SELWYN DISTRICT COUNCIL

IN THE MATTER of Private Plan Change 54

Report on submissions relating to Plan Change 54

**Ballymena Holdings Ltd request to rezone 31.3 ha of land at
Pocock Road, Springfield from
Rural (Outer Plains) to Living 2**

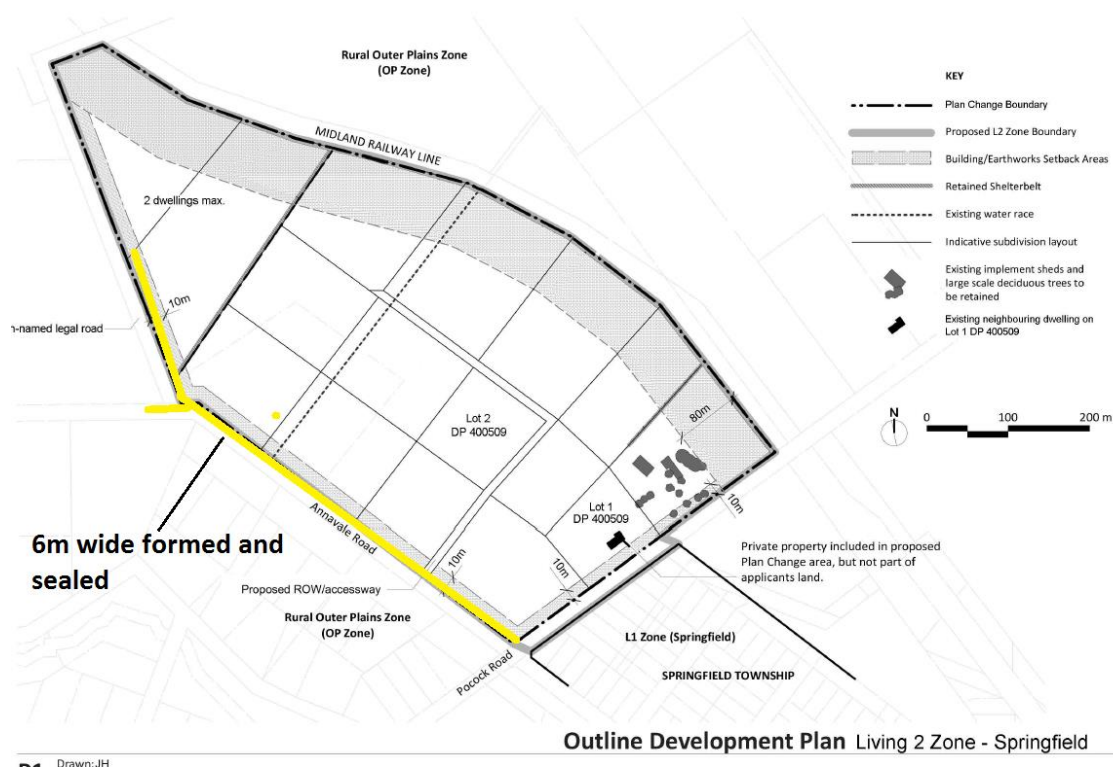
The proposed Right of Way appears to be servicing 8 lots, rather than the maximum of 6 allowed (Table E13.4 Township Volume). If so a legal road to vest would be required and on that basis the same standard for Annavale Road described above should apply, including a turnaround facility.

Proposed Outline Development Plan

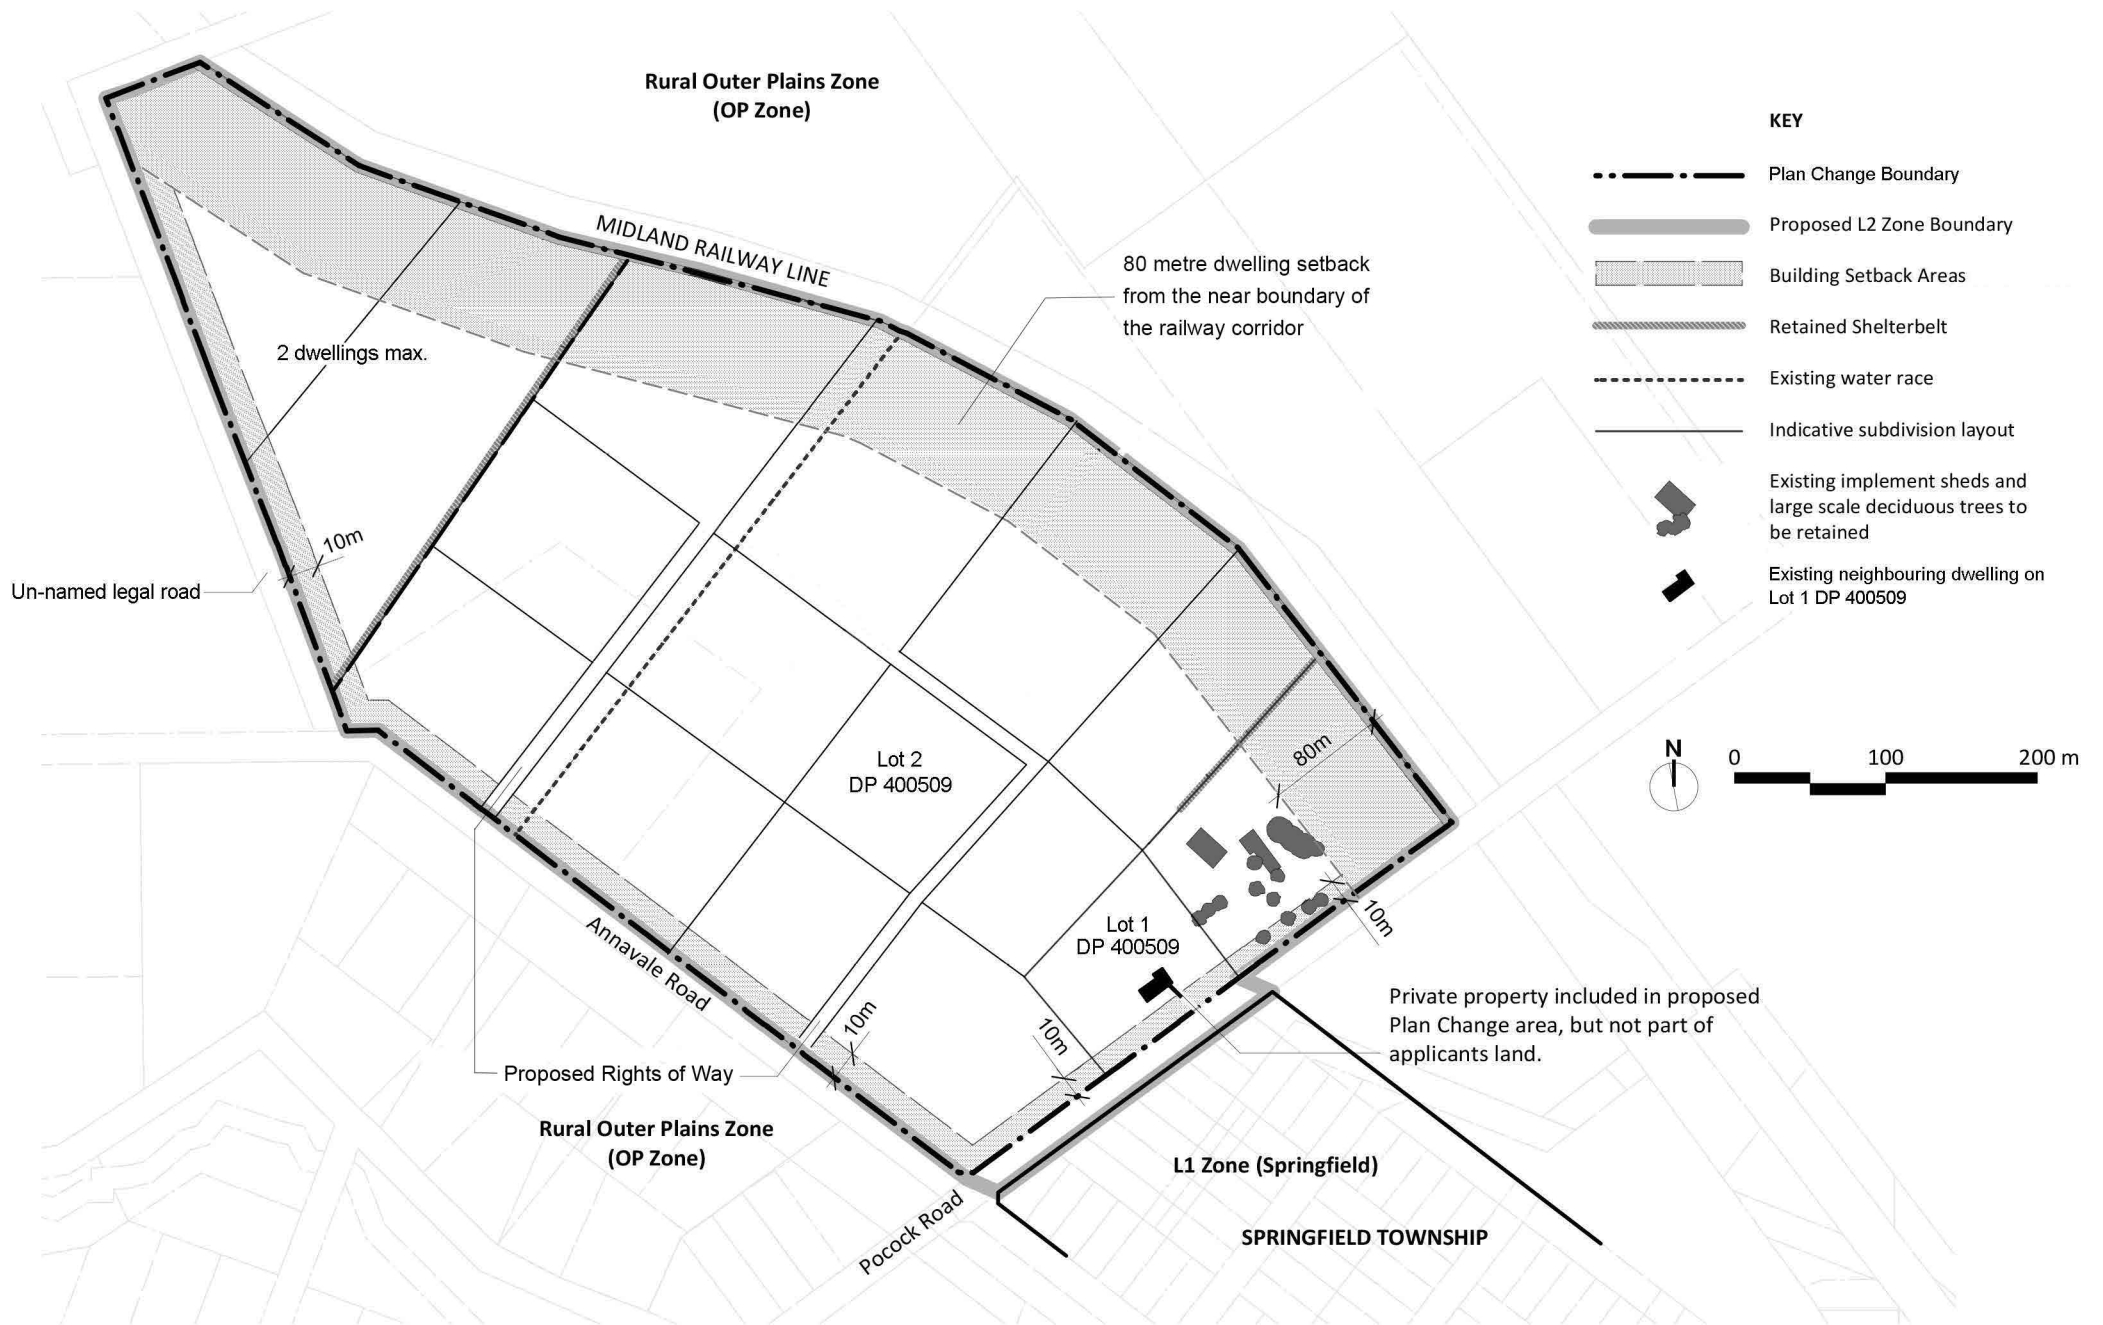
- 7.19 The application does propose a number of relatively minor amendments to include reference to the site's Outline Development Plan, lot density and number, and to address site-specific servicing, site coverage, and building setback matters. I agree with the need for the proposed amendments and that their drafting is appropriate. As noted above, further amendments to the rule package and/or the ODP may have been agreed between the applicant and the Saunders-Limbes regarding management of reverse sensitivity effects, with these parties able to advise the Commissioner of any such agreement.

- 7.20 A collated set of proposed District Plan amendments is attached as **Appendix 6**, with a copy of the ODP, as amended by the applicant's RFI response, attached as **Appendix 7**.
